## Author's response to the comments received for manuscript "esurf-2022-12"

As requested by the handling editor, the following pages contain a point-by-point reply to the comments provided by the two referees that reviewed our first submission (esurf-2022-12).

## Referee #1 (Greta Wells):

## Referee #2 (Jan-Christoph Otto):

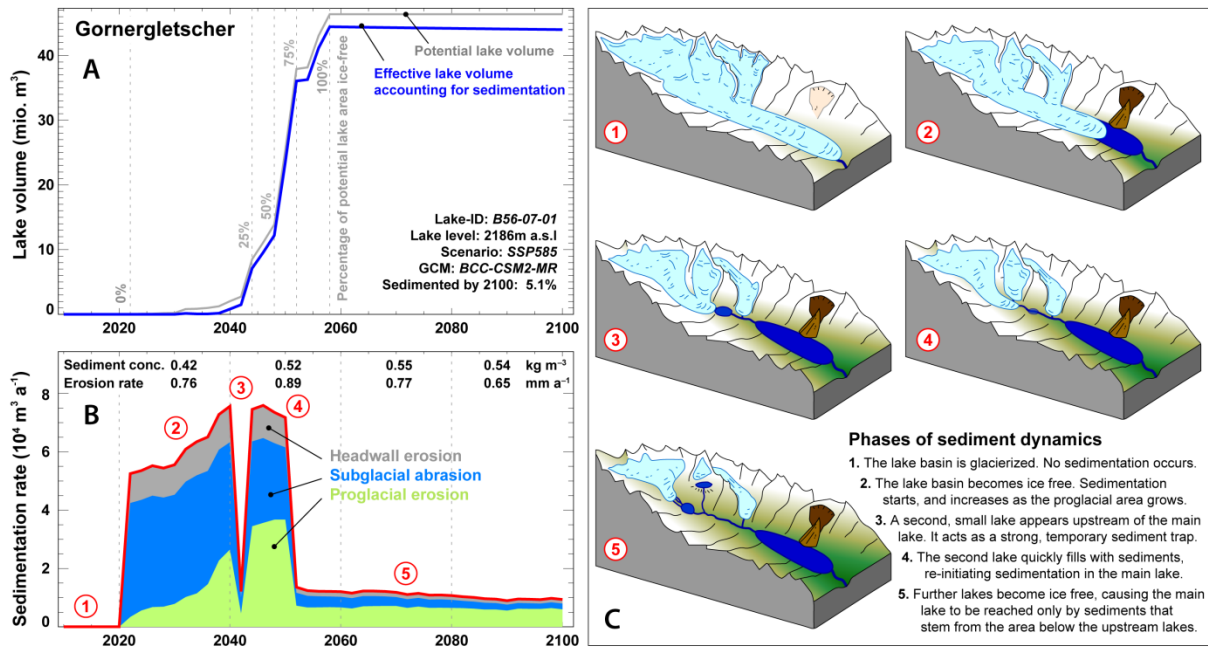
**[RC 1.06]** *The figures are great, but I think the paper would be strengthened by adding a schematic diagram to accompany the sediment input graph in Figure 5. Maybe a cartoon visualization of a lake (like the cross-section shown in Figure 6) that shows the locations on the landscape of sediment source zones (headwall erosion, subglacial abrasion, and proglacial erosion). Also maybe draw upstream lakes to illustrate sediment trapping. Though the information is described in the text and existing figures, a “landscape view” would help to visualize sediment sources and transport.*

**[AR 1.06]** This is an excellent suggestion, and we have produced such a cartoon now (reproduced here below, on the next page). We intend to include this cartoon as panel “C” in Figure 5. The Figure’s caption will be changed accordingly.

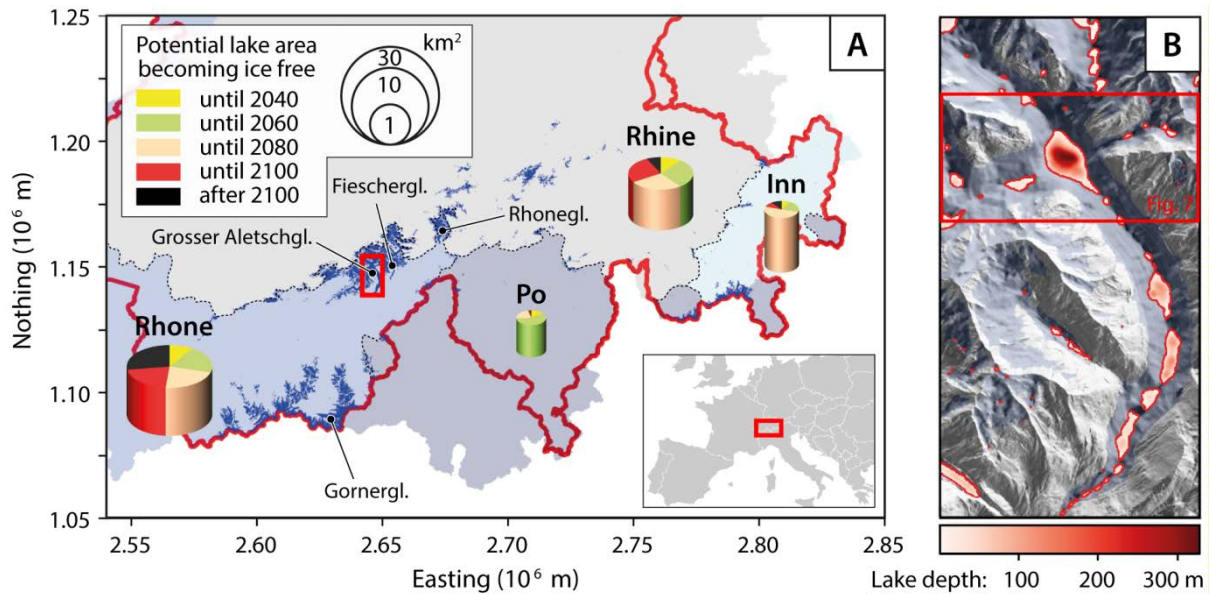
**[RC 1.07]** A map showing the locations of the glaciers mentioned in the text would be helpful (i.e. those in Table 1) – though I did notice that the lake polygon shapefiles are online in “data availability”.

-----  
**[RC 1.23]** Line 305 (Figure 1): (1) delineate the catchment boundaries more clearly on the map – it is difficult to distinguish between the Rhine and Inn basins, particularly. (2) It would also be helpful to add an inset map showing the study area location within the larger region/Switzerland. (3) The label “B” also does not clearly show up on the panel.

**[RC 2.10]** *Figure 1 A: (1) rename the legend items...it seems like you depict the total deglaciated area and not the total lake area as described in the figure caption. (2) What does "1e6" represent at the upper left and lower right corners?*

**[AR 1.07]** Also this is a very good suggestion. To take it into account, we will amend Figure 1A and include the names of the glaciers mentioned in Table 1. Similarly, we will include the location of the glacier shown in Figure 5. We think that this solution (i.e. the inclusion of the names in Fig. 1) is more elegant than adding a potential, separate map. The amended Figure is shown here below (next page), and takes into account **RC 1.23** and **RC 2.10** too. The Figure’s caption was adapted to flag the indicated locations explicitly.

**[AR 1.23]** All three suggestions are very pertinent, and we have amended the figure correspondingly. The new figure, as we will include it in the revised version of the manuscript, is shown in **AR 1.07**.

**[AR 2.10]** (1) This was indeed a mistake and the legend will be corrected. (2) "1e6" was standing for "10<sup>6</sup>", which was needed for the units of the coordinate system. We recognize that the information must have been confusing, and will amend that in the revised figure. The figure as it will appear in the revised manuscript is shown in our answer to **RC1.07**.
